SERVICE BULLETIN #48

DATE: 13 January 1986

SUBJECT: A723 Oil Cooler Lines

ROTORCRAFT AFFECTED: S/N 0002 thru S/N 0500 unless protective sleeves are already on the A723 oil cooler lines.

Figure 1

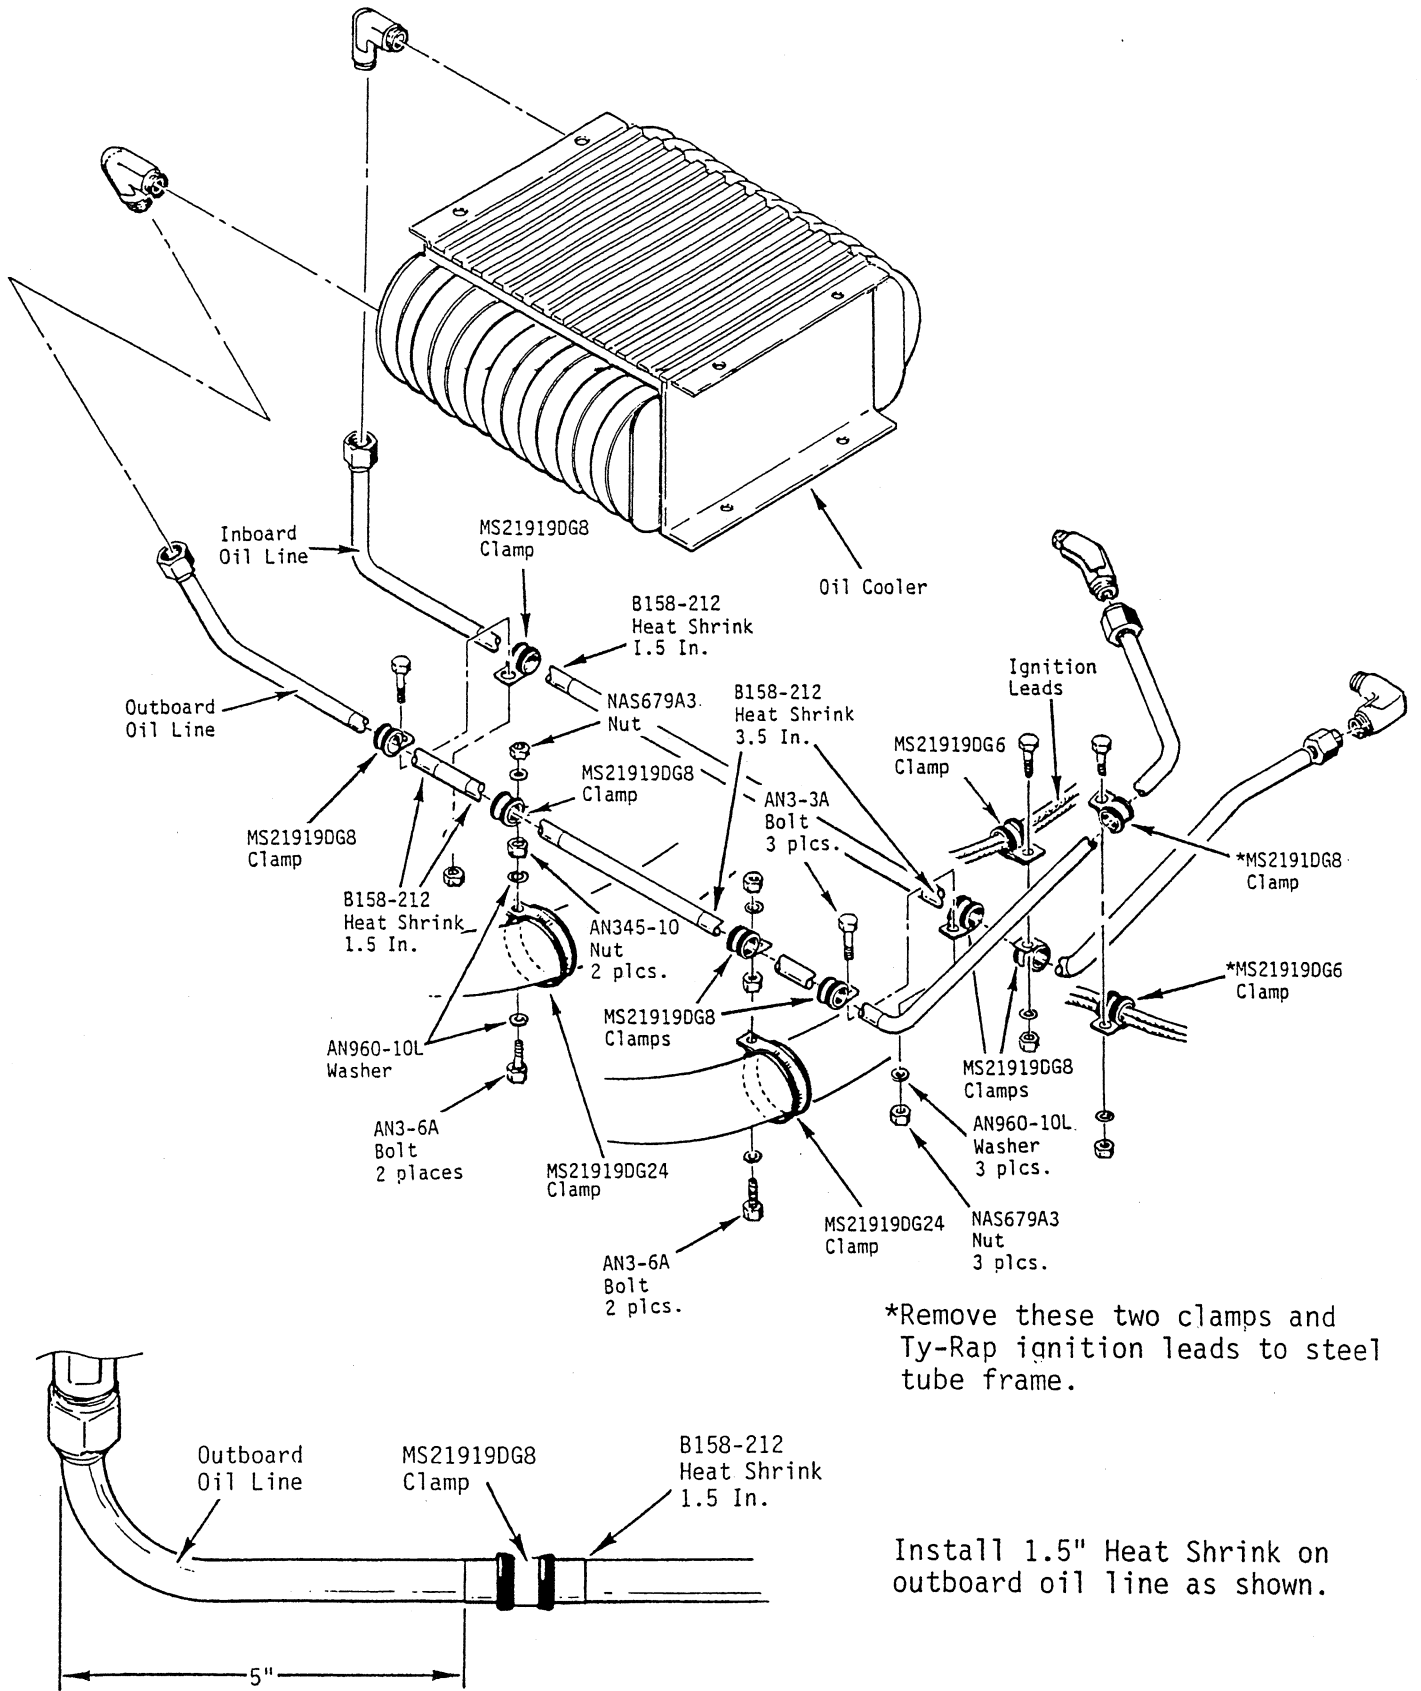
6. Clean the protective sleeves and oil lines of any residual engine oil. Position the sleeves per figure 1. Apply heat with a heat shrink gun or suitable heat source. Reposition the sleeves as required while they are shrinking.

7. Install the new MS21919DG24 clamps onto the intake tubes. Install the new MS21919DG8 clamps over the protective sleeves on the oil lines. Secure the clamps per figure 1 without stressing or pre-loading the oil lines.

8. Secure the two ignition leads to the inboard oil line with a MS21919DG6 and a MS21919DG8 clamp, per figure 1. Do not secure any other items to the oil cooler lines. Reroute and resecure any items away from the oil lines.
